PLANNING APPLICATION PLN-21-0006

7 CHURCH STREET, CRESSY

PROPOSED THREE UNIT DEVELOPMENT FOR JID CONSTRUCTIONS AT 7 CHURCH ST. CRESSY

REFERRAL OF DEVELOPMENT APPLICATION PLN-21-0006 TO WORKS & INFRASTRUCTURE DEPARTMENT

LANDSCAPING PLAN
1:200

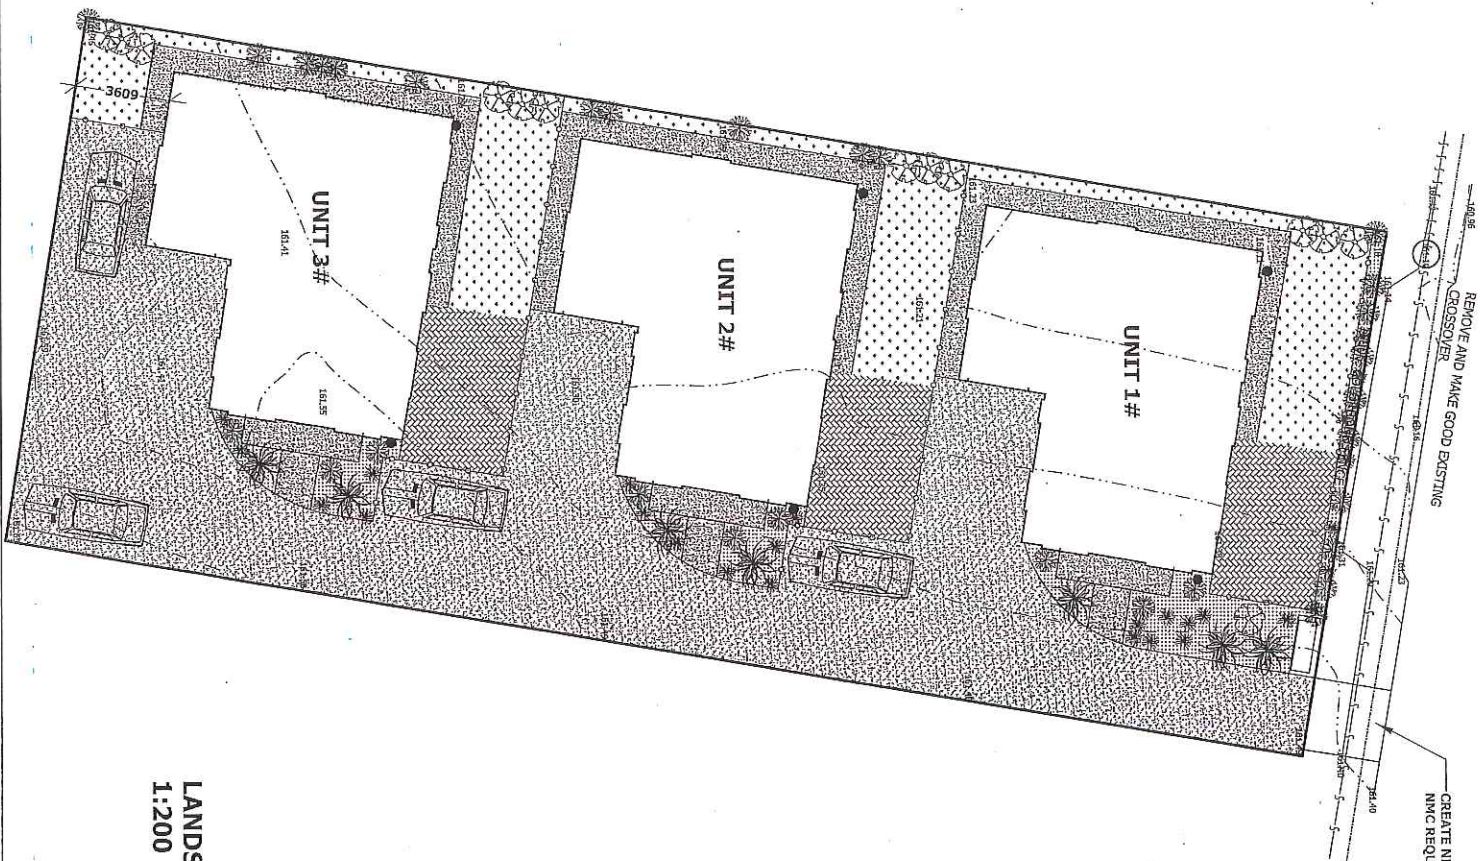
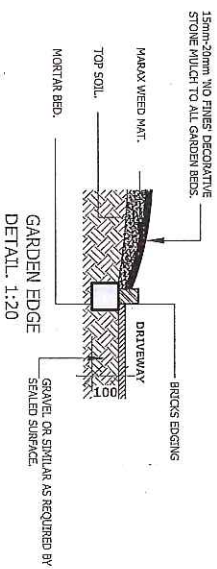
- c. Is the verandah extent intended as shown on the floor plan drawing or the lesser extent shown on all other drawings?
2. Are site coverage calculations on the landscaping plan correct and if not, do they comply with requirements of the Northern Midlands Interim Planning Scheme?

*2. Are site coverage calculations on the landscaping plan correct and if not, do they comply with requirements of the Northern Midlands Interim Planning Scheme? **Yes, they are correct, and we believe they comply.***

DIMENSIONING PLAN
1:200

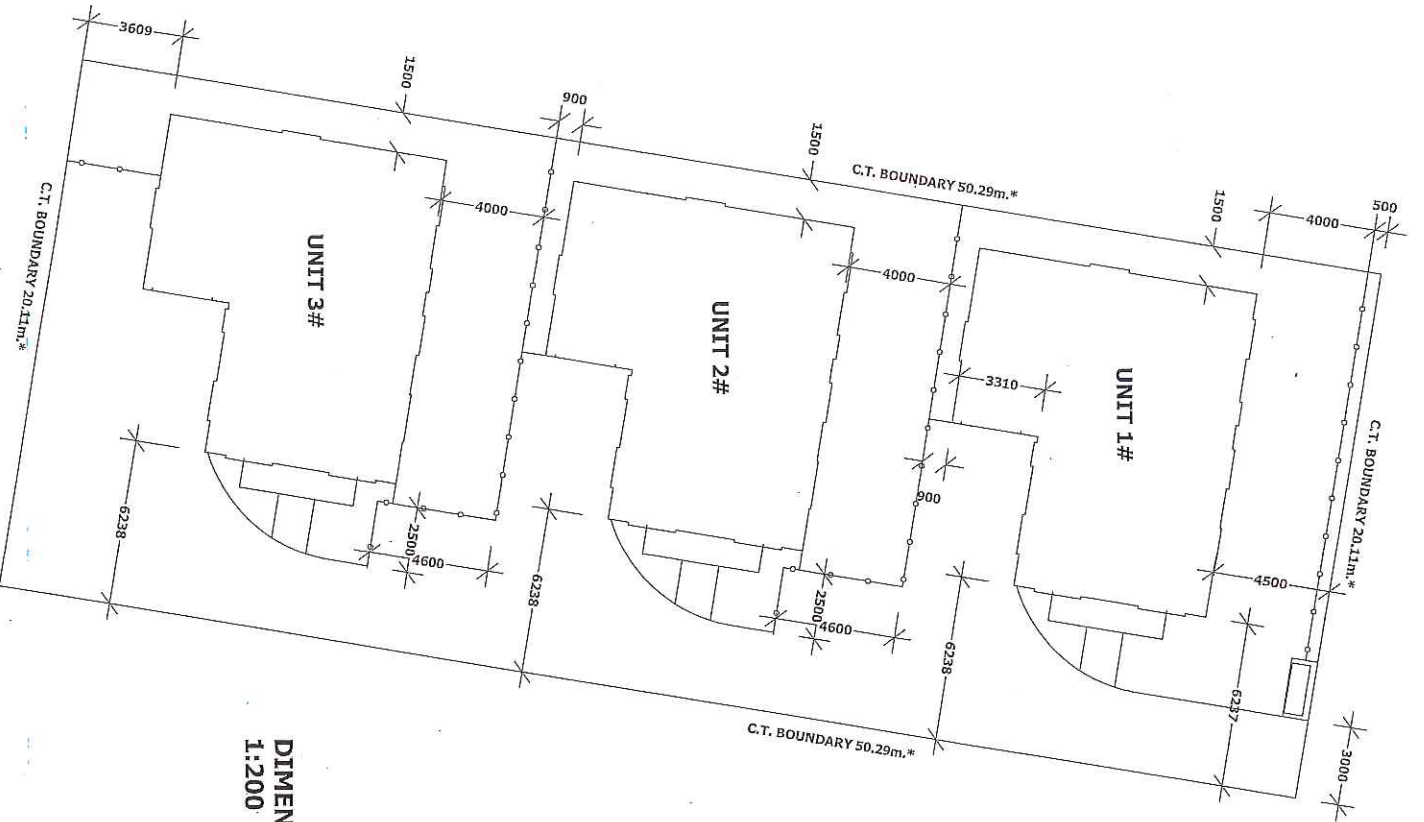
- a. If the overall dimensions shown on the floor plan are correct, is the rear setback 3609mm as shown on the dimensioning plan?
 - b. If the overall dimensions shown on the floor plan are correct, are the side setbacks 1500mm and 6237/6238mm respectively as shown on the dimensioning plan?

*a. If the overall dimensions shown on the floor plan are correct, is the rear setback 3609mm as shown on the dimensioning plan? **Yes***

*b. If the overall dimensions shown on the floor plan are correct, are the side setbacks 1500mm and 6237/6238mm respectively as shown on the dimensioning plan? **Yes***

FLOOR PLAN
1:100
 FLOOR AREA - 119.46m²
 VERANDAH AREA - 9.66m²

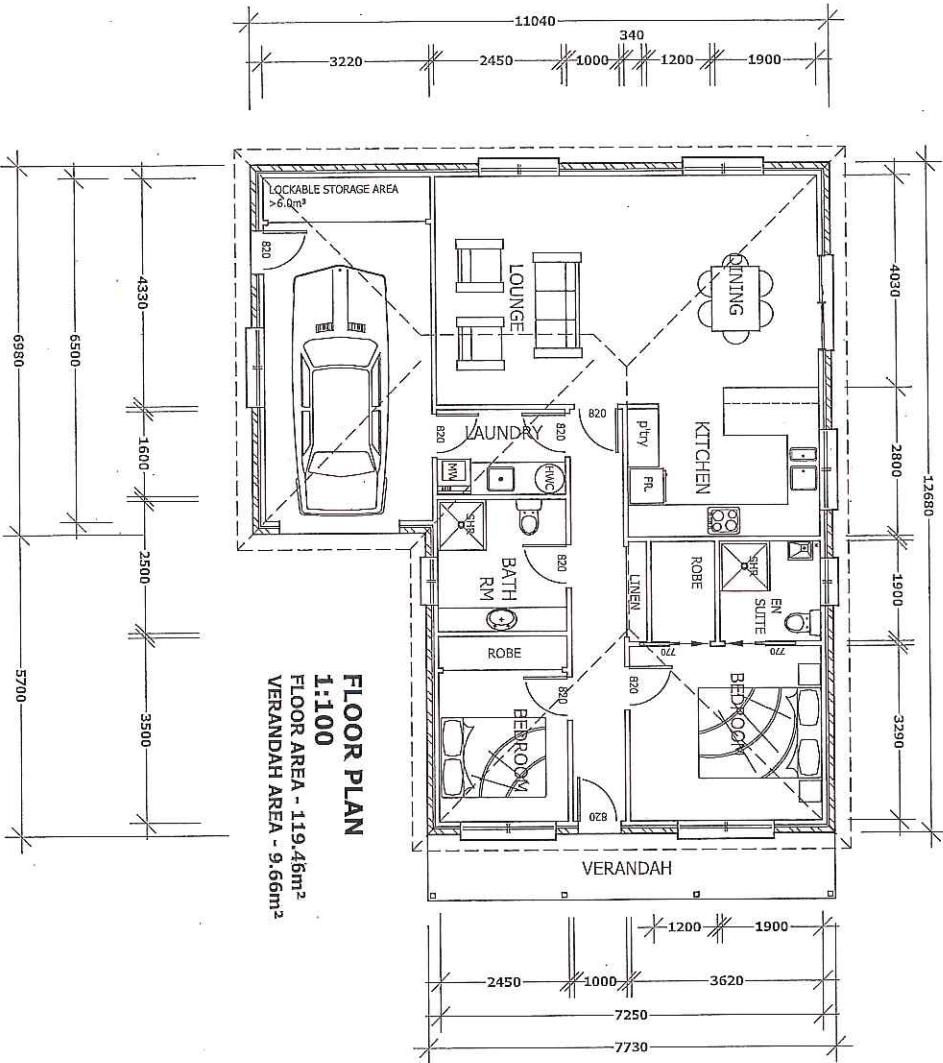
1. Are the overall dimensions of the units (excluding verandah) on the floor plan drawing correct given the different internal layout shown on the site plan?

*c. Is the verandah extent intended as shown on the floor plan drawing or the lesser extent shown on all other drawings? **The lesser one.***

*1. Are the overall dimensions of the units (excluding verandah) on the floor plan drawing correct given the different internal layout shown on the site plan? **Yes, the overlay is exact which I have attached showing the lighter line over the top being the proposed unit as per the site plan.***
